MACTHOMPSON SITE PLAN

SP# 12-21

STAFF REPORT

PLAN UNDER REVIEW: Macthompson Site Plan, 48 Lowell Road, Tax Map 190 Lot 191, Hudson, New Hampshire; prepared by Benchmark LLC, 1F Commons Drive, Suite 35, Londonderry, New Hampshire 03053; prepared for owner Macthompson Realty, Inc., 3 Marmon Drive, Nashua, New Hampshire 03060; consisting of 10 sheets with General Notes 1-27 on Sheet 3; dated August 3, 2021.

SCALE: 1"=30' SHEET 2 OF 10 AUGUST 3, 2021

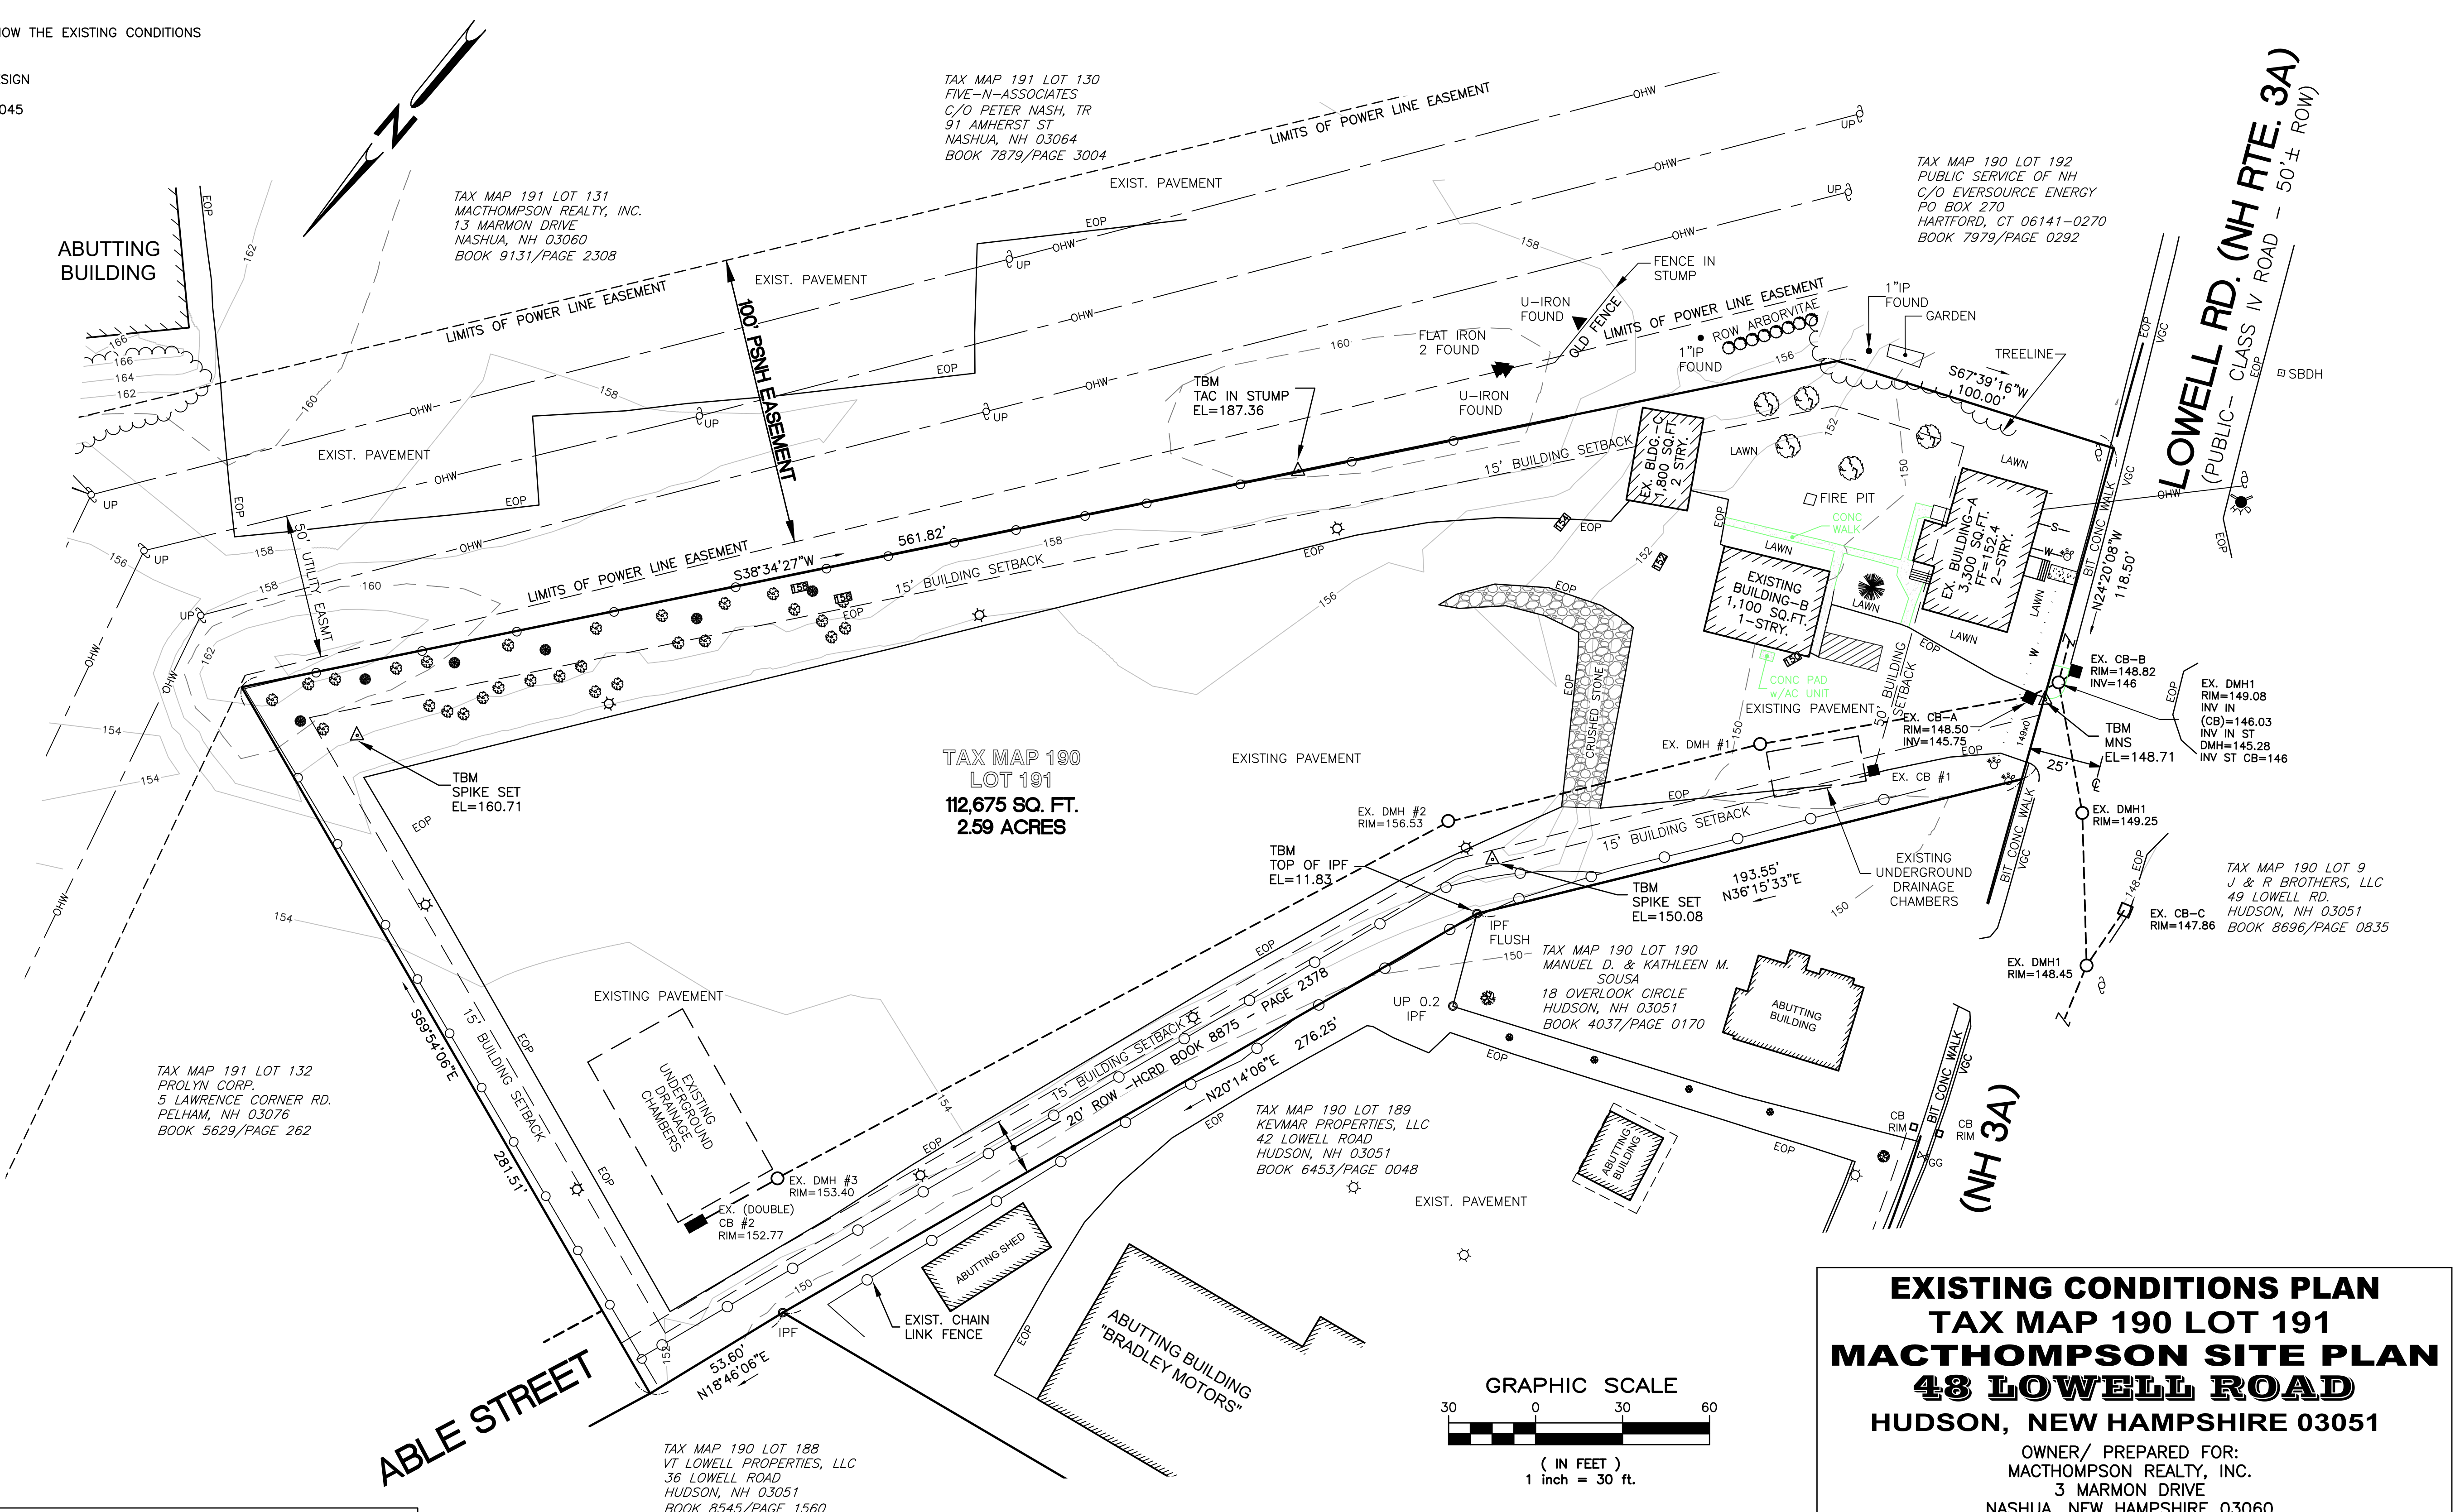
- b. HR 276-13. The applicant has shown the new sewer connection tying into an existing sewer service. We note that this service is not shown on the existing conditions plan. The applicant should provide additional information about this service location.

SCALE: 1"=30' SHEET 3 OF 10 AUGUST 3, 2021

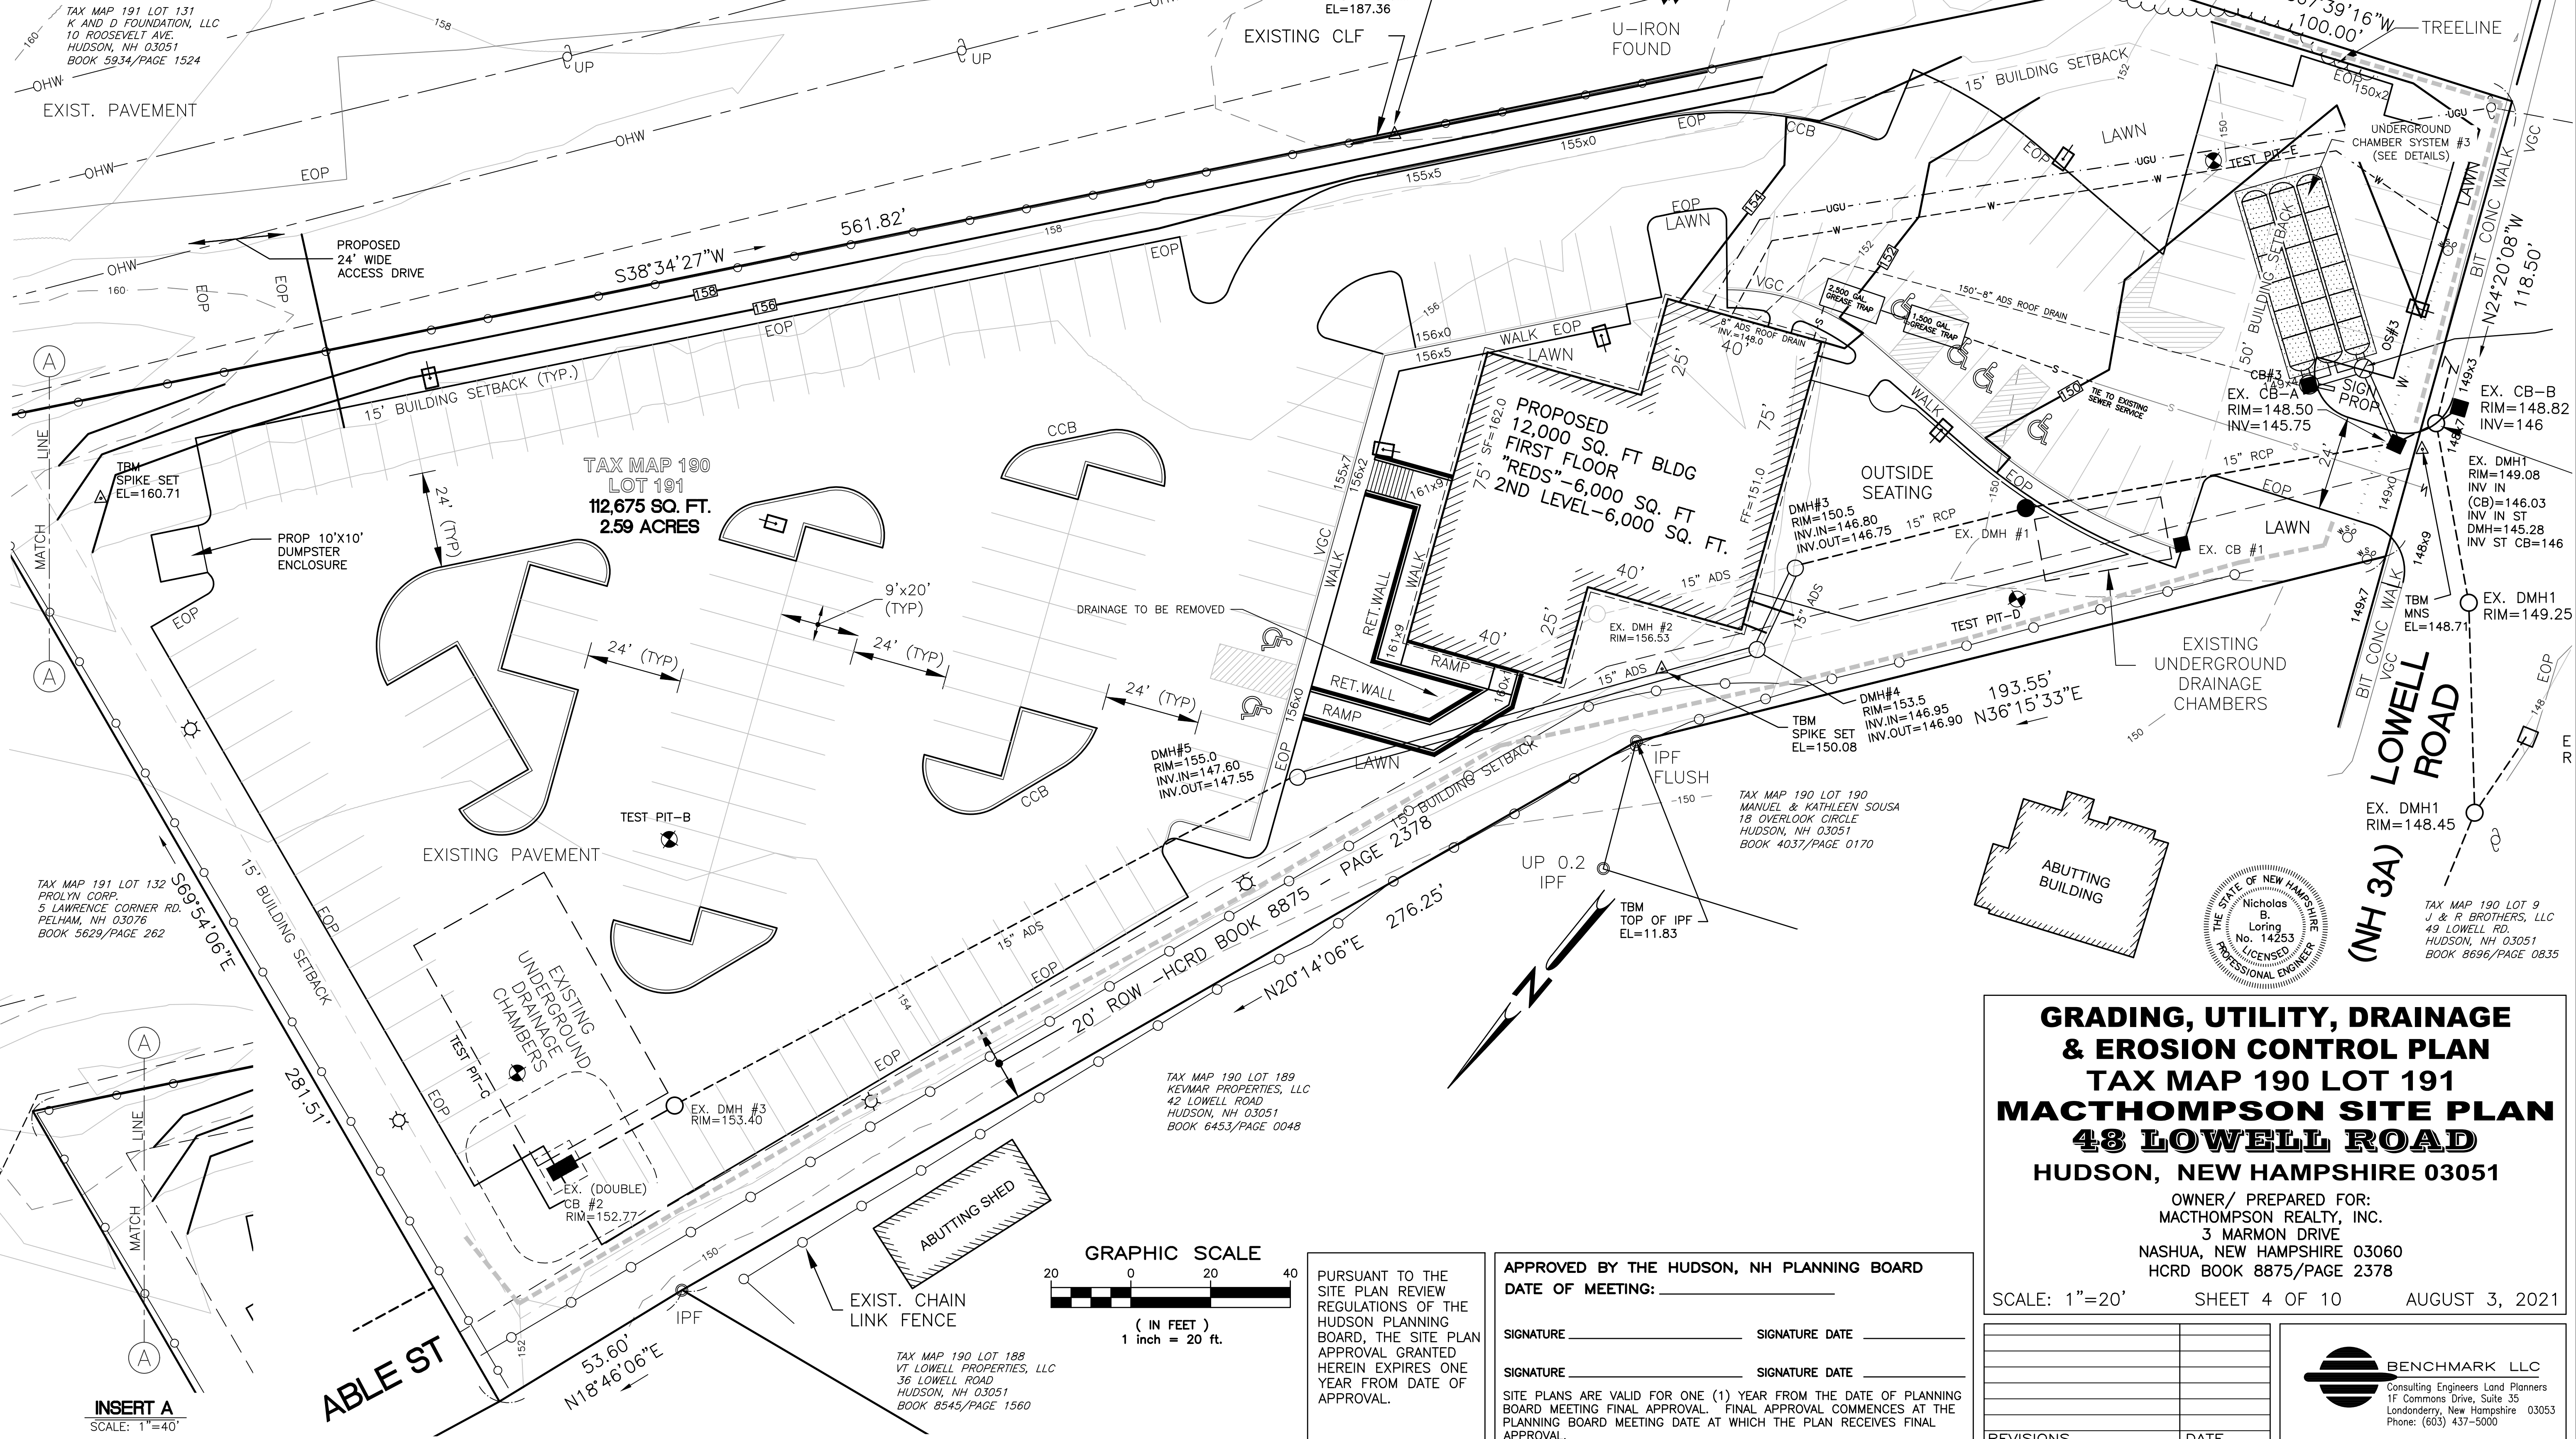
As noted in Staff Comment #1, the Applicant is requesting a waiver for this requirement. The submitted plan has parking spaces within the green area buffer.

As noted in Staff Comment #1, the Applicant is requesting a waiver for this requirement. The submitted plan provides only 32.8% of open space and does not meet the 35% requirement.

The parking lot in the submitted plan intrudes these areas, which is not allowed. As noted in Staff Comment #1, the Applicant is requesting a waiver for the requirement prohibiting parking within the green area buffer and side setbacks.

- 7. Note on Signage:** Please revise General Note 17 on Sheet 3 to “All signs are subject to approval by the Hudson Zoning Administrator prior to installation thereof.”

Further, the location of the proposed sign on the site plan does not match the location shown in the rendering found on Sheet 10. The Applicant should be aware that the proposed sign is required to be setback 25-feet from the property line.
